ORDERS UNDER SECTION 96 (2) OF ACT III OF 1910.

MUNICIPAL ENGINEER'S OFFICE,

— OF PROPOSED BUILDING ON PLOT No. 45 A25 —

— NAPIER QUARTER —

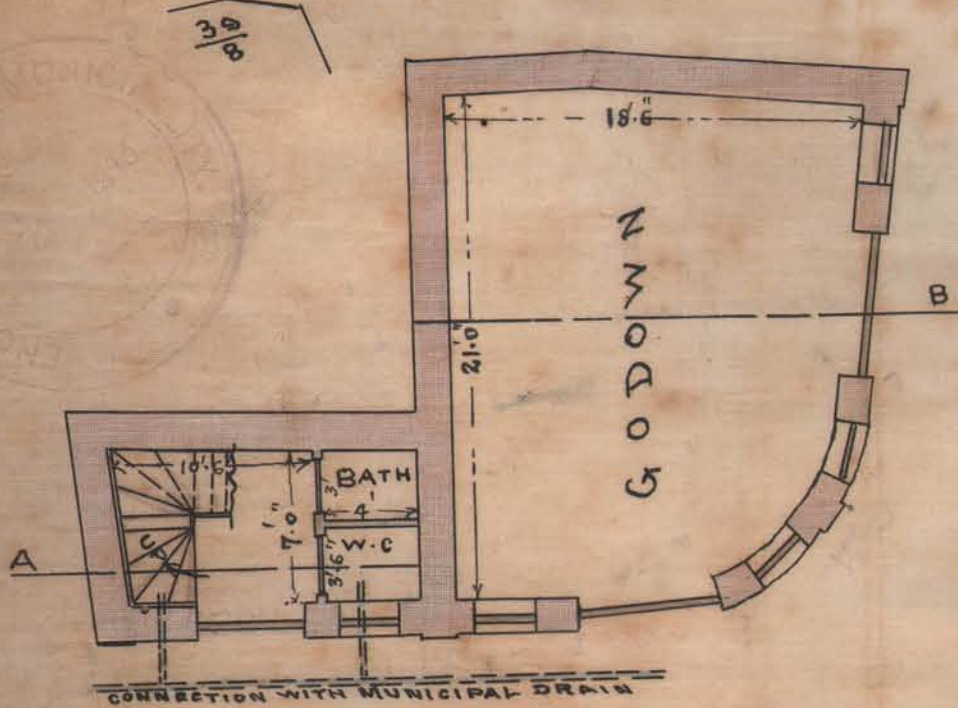
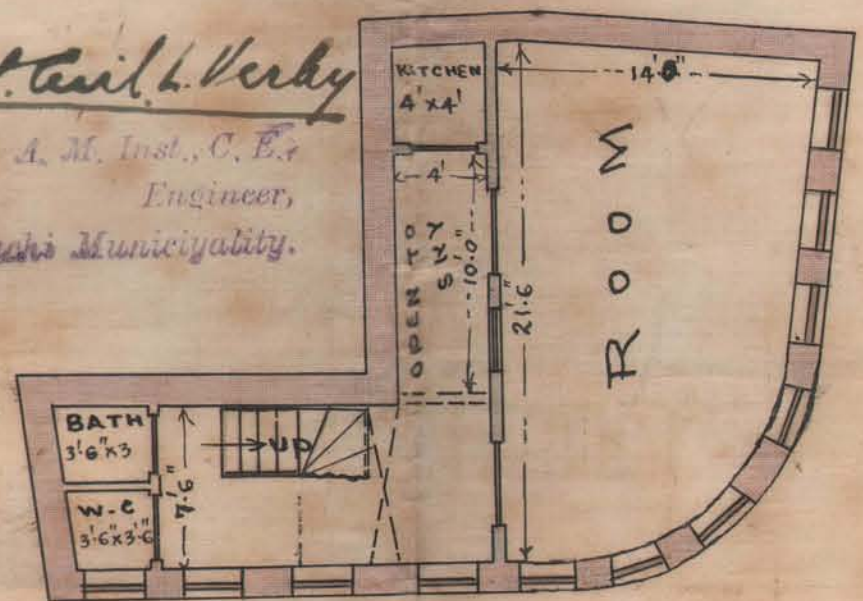
With reference to his application dated 6th instant, with a plan for building a house on plot No.45, A-25, Napier quarter, Mr. Lekhraj Bhojmal is informed that the room on the upper floor is not properly ventilated. The kitchen cannot be allowed in the living room and proposed store room should be substituted by kitchen and the living room properly ventilated.

Ref. to this
App. of 6th inst. with a plan
for building a house on
plot no 45, A-25, Nagpur
Sr. Mr. Lekhraj Bhoghoram
~~is~~ is informed that
the room on the upper floor
is not properly ventilated.
The kitchen cannot be
allowed in the living
room & proposed store-
room should be
substituted by kitchen
& the living room
properly ventilated.

Returned to the Engineer, Karachi Municipality, with the following
remarks.— *Room on the upper floor is not properly
ventilated; Kitchen cannot be allowed in the living
room: proposed store room should be substituted
by kitchen & the living room properly ventilated*

The plan is returned for amendment.
